Review of Road Safety

Cyclist interaction within the mixed running alignment, Newcastle Light Rail

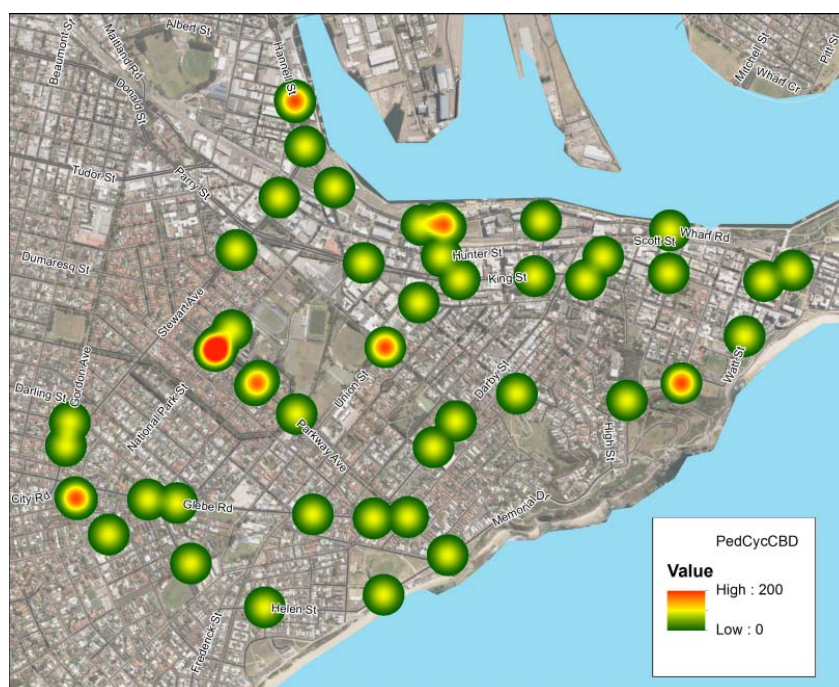
| No. | Description of road safety deficiency | Photo of road safety deficiency | Crash frequency | Crash severity | Level of risk | Response to identified issue |
|-----|---|---|-----------------|----------------|---------------|------------------------------|
| 1 | <p>Scott Street westbound at Pacific Street – cyclists travelling westbound in the traffic lane are required to cross the light rail tracks at an angle that is not perpendicular. This presents a trap hazard for bike wheels with the potential for cyclists to fall onto the roadway into the path of oncoming traffic and light rail vehicles.</p> <p>This issue is exacerbated by the lack of permanent advisory signage warning cyclists of the hazard. The existing signage is temporary and is not positioned at the point of need, being located at the far end of the intersection after a cyclist has passed the hazard.</p> |  | Probable | Serious | Intolerable | |
| 7 | <p>Scott Street eastbound at Newcomen Street – cyclists travelling eastbound in the traffic lane are required to cross the light rail tracks at an angle that is not perpendicular. This presents a trap hazard for bike wheels with the potential for cyclists to fall onto the roadway into the path of oncoming traffic and light rail vehicles.</p> <p>This issue is exacerbated by the lack of permanent advisory signage warning cyclists of the hazard.</p> |  | Probable | Serious | Intolerable | |
